SEWAGE DISPOSAL SYSTEM

MARYLAND STATE DEPARTMENT OF HEALTH

RE: Percolation Test Results – A519619
16082 AE Mullinix Road, Wm. Slagle Farm, Lot 3
Establish Reserve Area to Support
Assisted Living Proposal

PERMIT CARD A.E. MULLINEX Rd
 SEPTIC TANK, LEVEL CLEANOUTS S.T. D.W. DAYWAY

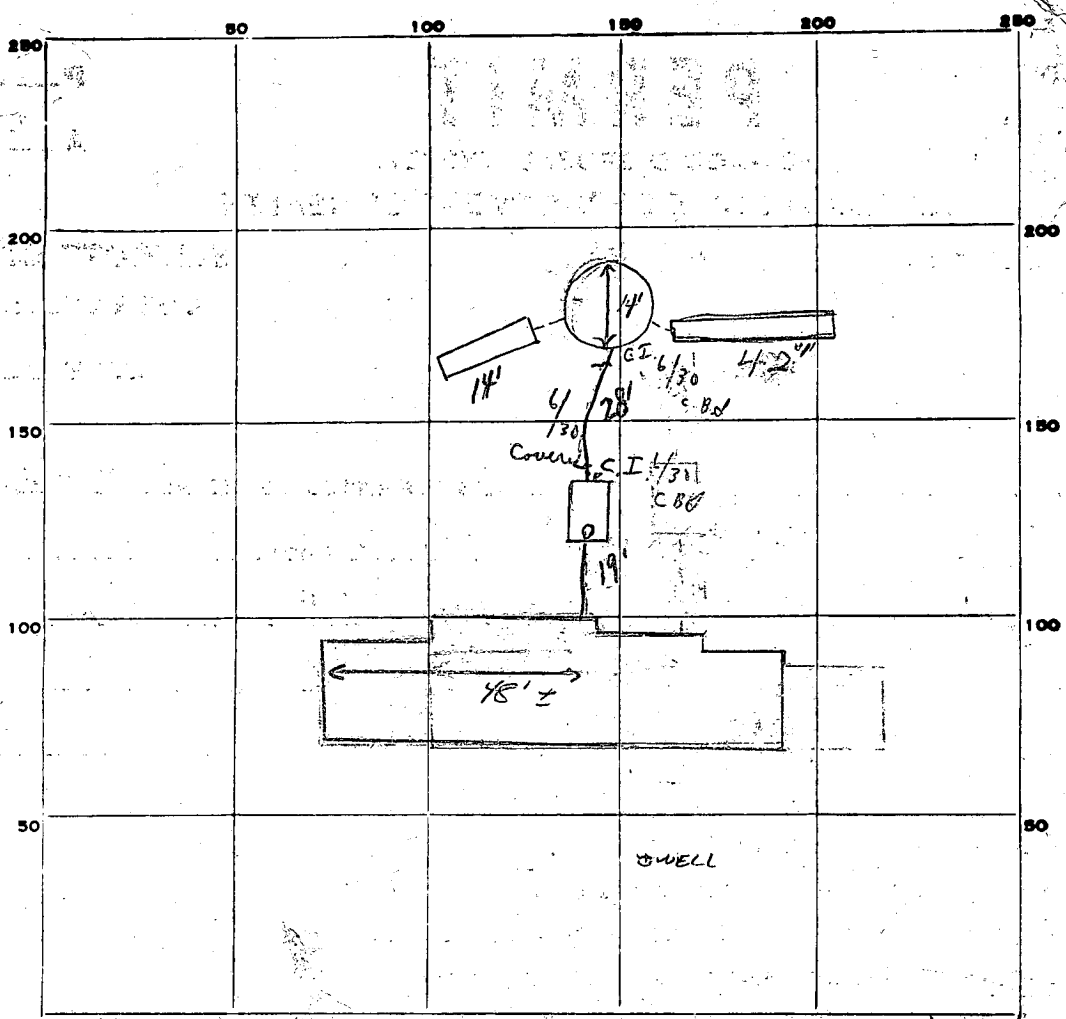
REMARKS OK To Add GRAVEL To Trench + Dry Well. SK + CBS 6-19-80
 6-20-80 No change should be 5' of buffer earth between Dry well + Trenches SK + GS 6/30/80 No top on dry well - ok to cover trenches only - to 2' of dry well. Need certifying statement on lengths of pipes and if cleanouts from septic tanks to dry well.
 OK to cover all work 7/8/80 SK C.B.S.

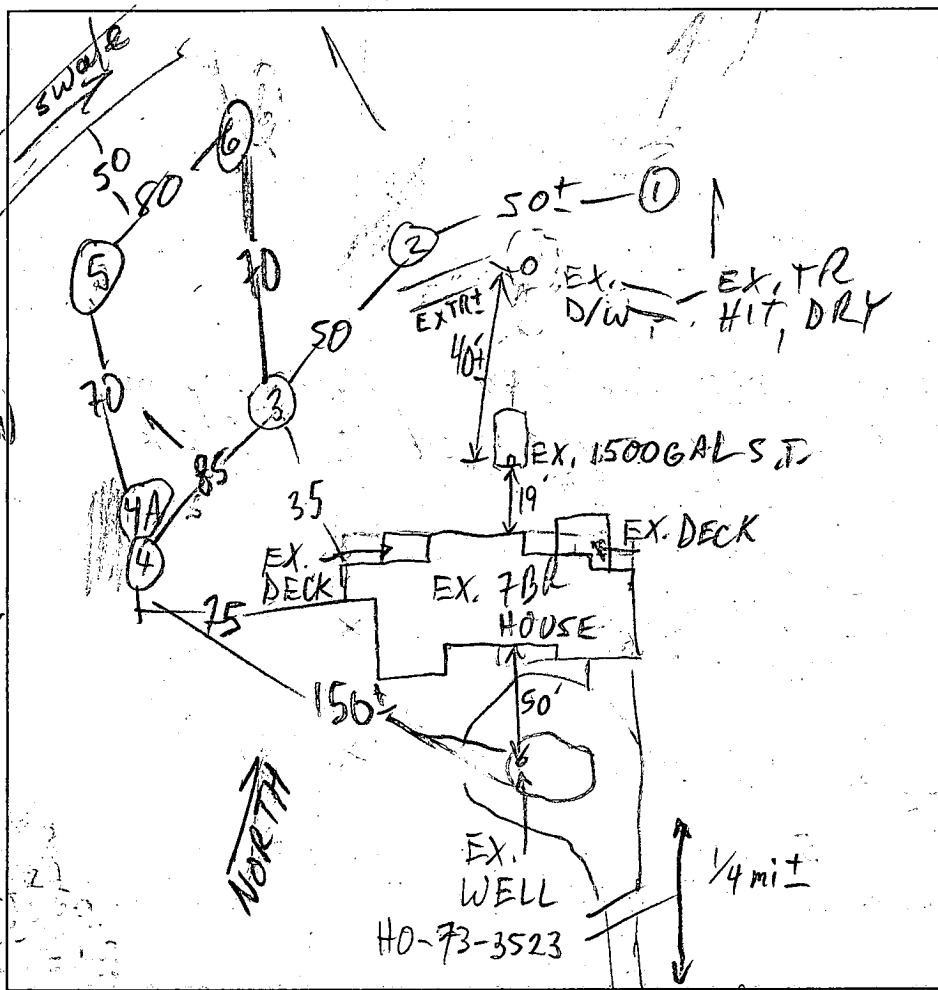
DATE	TEST #	DEPTH	START	BREAK 1" DROP	STOP 2" DROP	TIME OF 2nd INCH	P/F/H
10/15/03	1	14 1/2	FAILS	DOWNHILL			M
	2	8 1/2"					F
	3	12					P
	4	11					P
	5	12					P
	6	11? sim. to ⑤	w/20-30% Rx pockets				P
	4A	11	FAILS	DOWNHILL			M

REMARKS D/W HAS ABOUT 3' H₂O LIKELY DUE TO FAST ROCK & SAND
 SANITARIAN M. Ripkin BACKHOE Hartfields OTHERS _____
 TEST HOLES USED IN SDA 3-6 AVG. PERC TIME < 7 SQ. FT/BR 180 (x0.62)
 TRENCH WIDTH 3 INLET DEPTH 5 MAX. BOT DEPTH 7 EFFECTIVE S/W 2
ABANDON ALL OF EX. SYS.
